MIL-F-16377/13A(SH)
AMENDMENT 2
27 June 1990
SUPERSEDING
AMENDMENT 1
30 January 1986

MILITARY SPECIFICATION

FIXTURES, LIGHTING; FLUORESCENT, GENERAL LIGHTING, 180 WATTS, 120 VOLTS, 60 HERTZ, DRIPPROOF, SYMBOLS 74, 74.1, 75 AND 75.1

FIGURE 10. Candlepower distribution curves for Symbols 74 and 74.1.

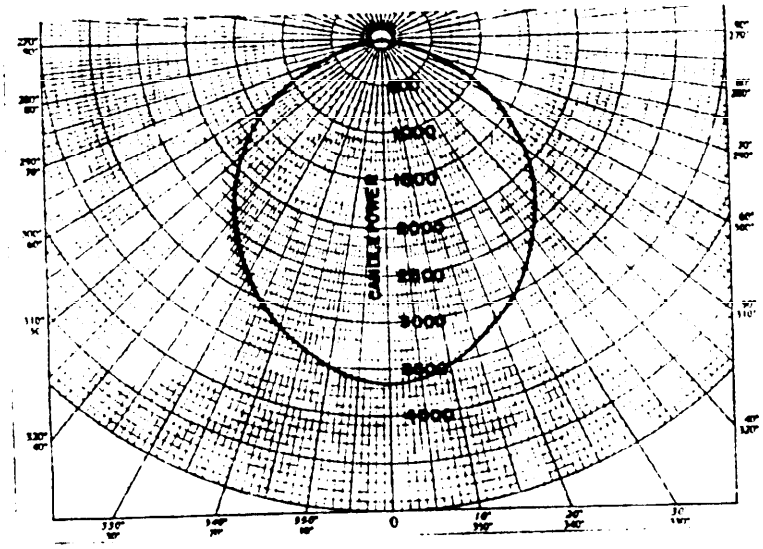
* FIGURE 10: Delete and substitute:

* FIGURE 10 (continued)

ANGLE	SYMBOLS 74, 74.1	ANGLE	SYMBOLS 74, 74.1
0	3650	65	900
5	3600	70	550
10	3500	75	250
15	3350	80	0
20	3175	85	0
25	3025	90	0
30	2800	95	0
35	2575	100	0
40	2375	105	0
45	2125	110	0
50	1850	115	0
55	1575	120	0
60	1250	125	0

Photometric test data:

Distance: 15 ft.
Plane: At right angles to long axis of fixture through geometric center of lamp.
Voltage: 115 volts, 60 Hz.
Ambient temperature: 75 F.
Lamps: Use lamps furnished with fixtures seasoned for at least 100 hours.
Ballast: Use ballast furnished with fixture.
Lamp correction: Distribution curves based on 4300 lumens per lamp.
